AGENDA
CITY OF GLENWOOD SPRINGS
Planning and Zoning Commission
Regular Meeting
MARCH 23, 2021
Council Chambers, First Floor
101 W. 8TH STREET
6:00 PM

MINUTES
City of Glenwood Springs
Planning and Zoning Commission
Regular Meeting
February 23, 2021
Zoom
6:00PM

TITLE	LOT 1 PROPOSED ZONING
DRAWING NO.	C-1.1

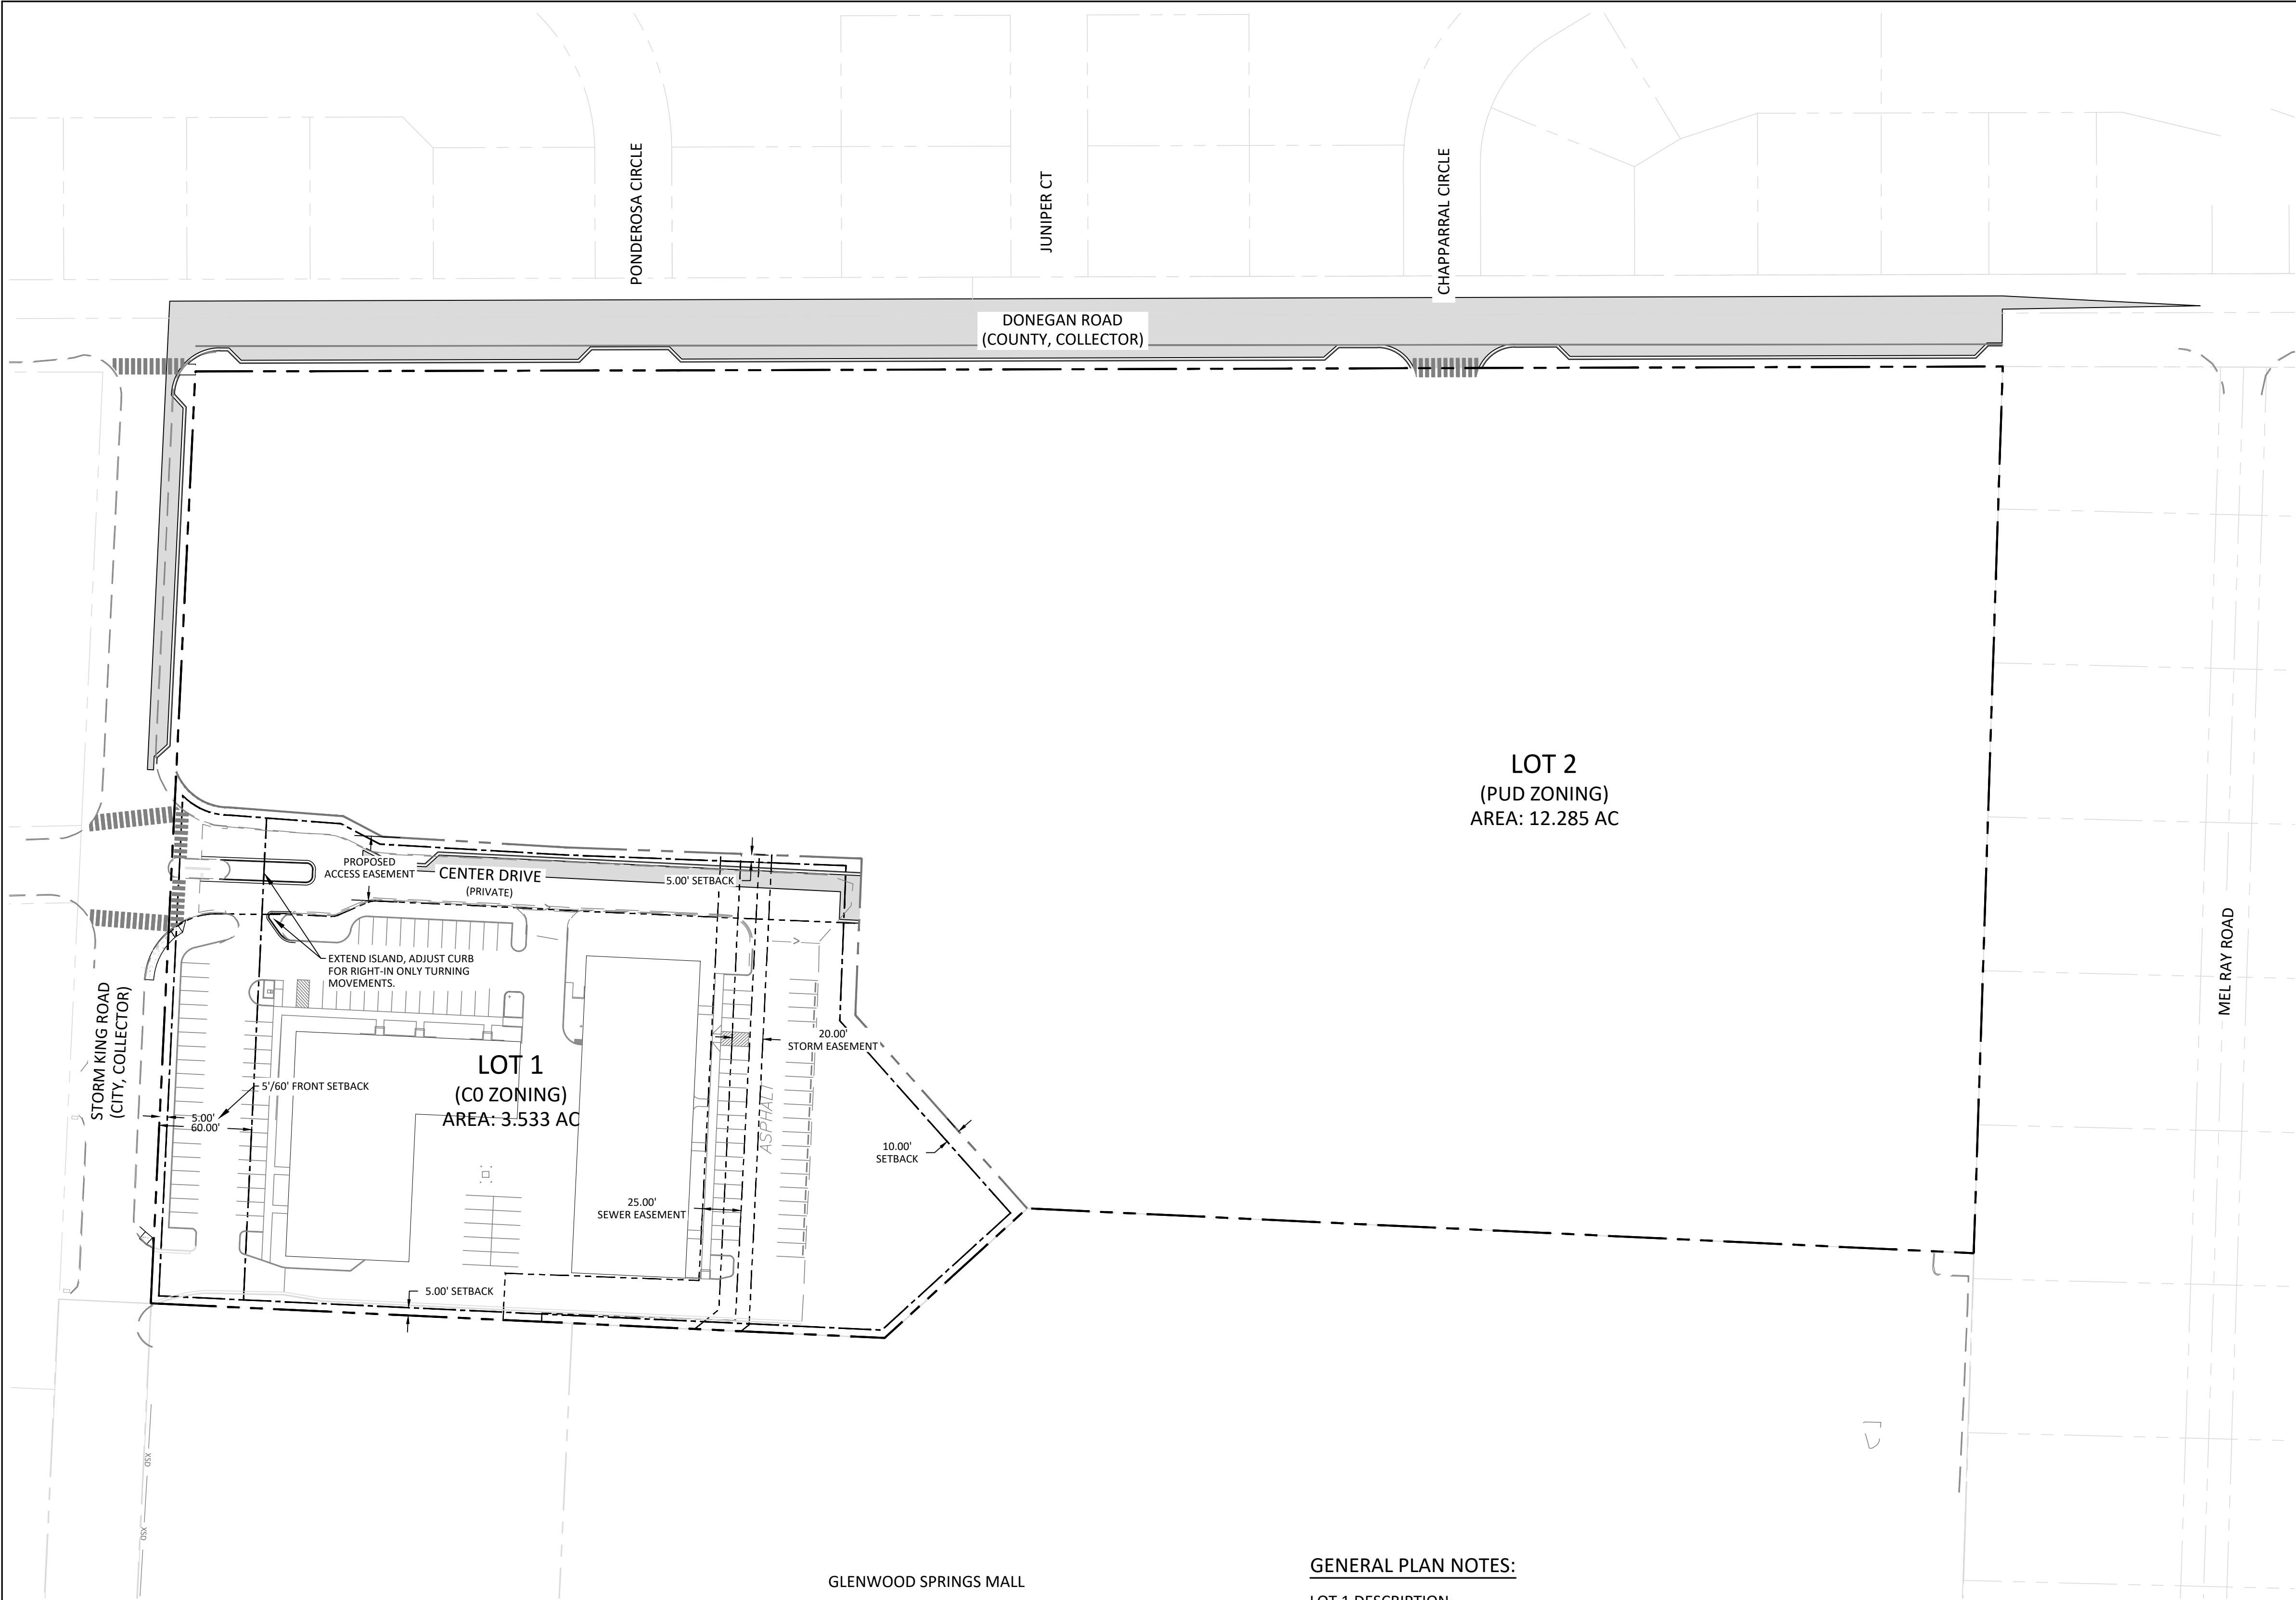
Plan C0.0	6	#6 System Improvement Fee and EQRs	480 Donegan	See changes made to Annexation Agreement
	Plan C1.1	1	Label % of total Site on all areas in summary	SE w/HCM	% of total areas are included in summary.
	Plan C1.2	1	I am concerned regarding the management/control of onstreet parking for use by the project in this area due to proximity to the school. Has any progress been made with the school in terms of shared parking during the daytime hours. I would think the traffic analysis would need to address the feasibility of this option.	480 Donegan	The Applicant added to available parking spaces, residential guest parking generally does not conflict with the school use. Residential and guest parking will be privately managed. On-street parking will be monitored between Monday to Friday during the school day to prevent residential and guest parking from using public streets.
	Plan C1.2	2	Applicant should consider off site bike/ped improvements to connect proposed infrastructure to the existing City network approximately 630 feet to the east.	SE	Proposed Bike/Pedestrian Improvements extend to Soccer Field Road as shown on C3.0 and C3.1

1 | LANDSCAPE FRAMEWORK PLAN

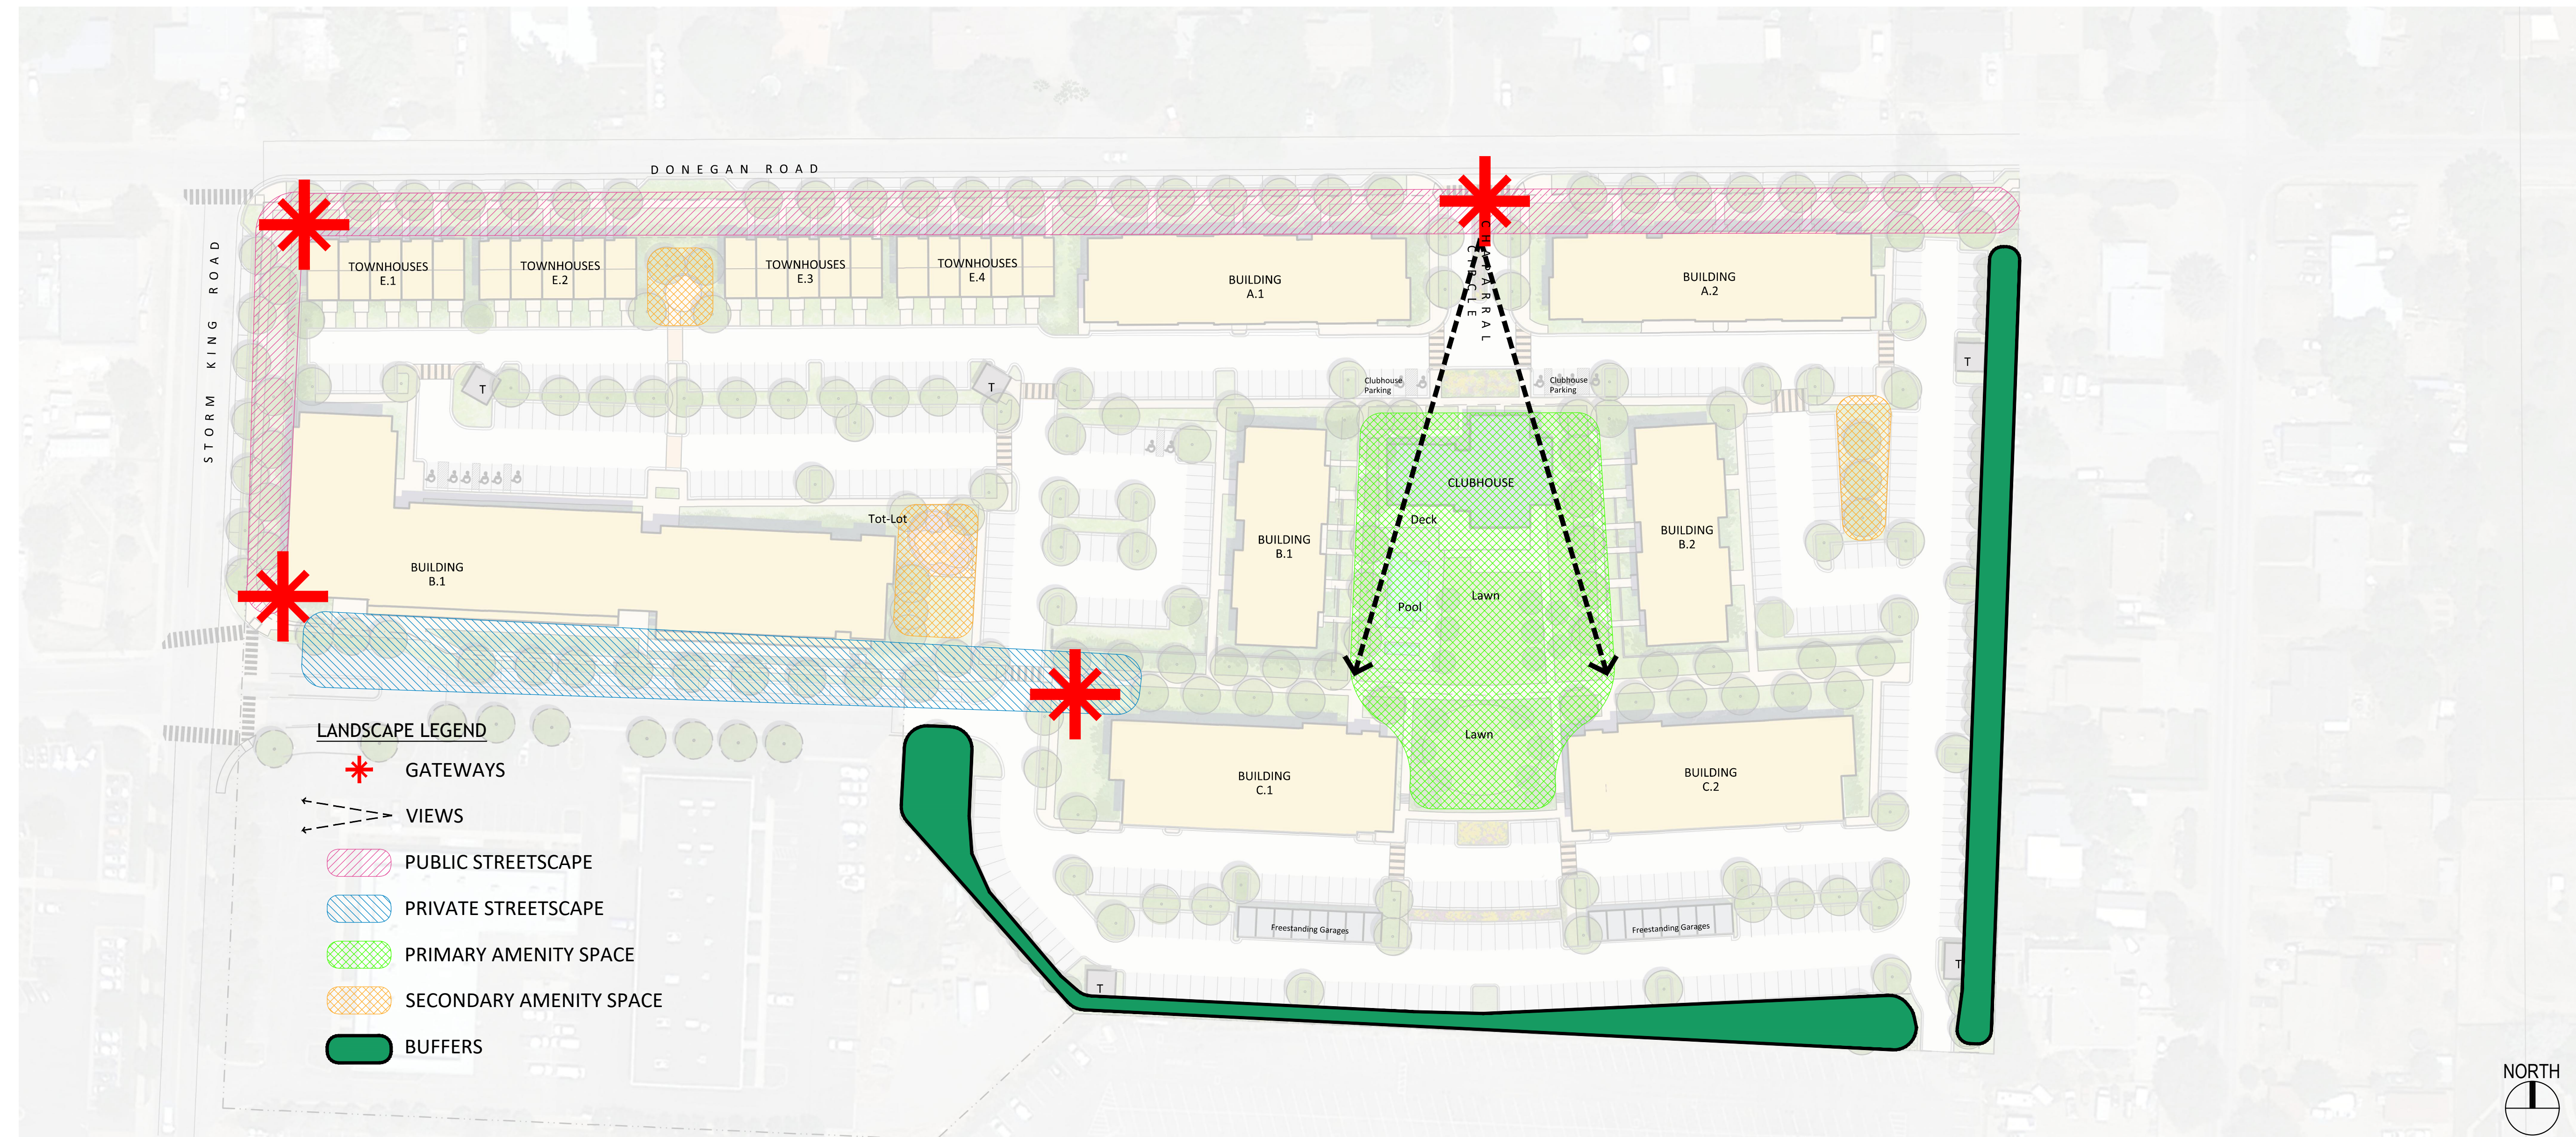
26		PLAN LA1.0	1	While a full landscaping plan is not required, I recommend adding a representative chart identifying the total amount of landscape and hardscape areas expressed in square feet and as a percentage of the total lot area. For parking areas, note square footage of landscaped area and as a percentage of the parking area; include total number of required and provided trees, shrubs, and perennials per the Code.	HCM	The Applicant provided a chart to identify the quantity of landscape areas required per Article 070.040. The calculations are shown on Sheet LA3.0. This information will be refined with more detail at the time of Major Site/Architectural Plan submission.
27		PLAN LA1.0	2	I would add cross section views which depict mature representations of the various landscaping buffer areas	HCM	The Applicant provided typical sections to describe landscape buffers, see Sheet LA 4.0.
28		Plan A1.0	1	These residential photos are not representative of west Glenwood.	HCM	The Applicant revised and expanded the precedent images to address local conditions, see Sheet A1.0 and design vision, see Sheet A1.1.
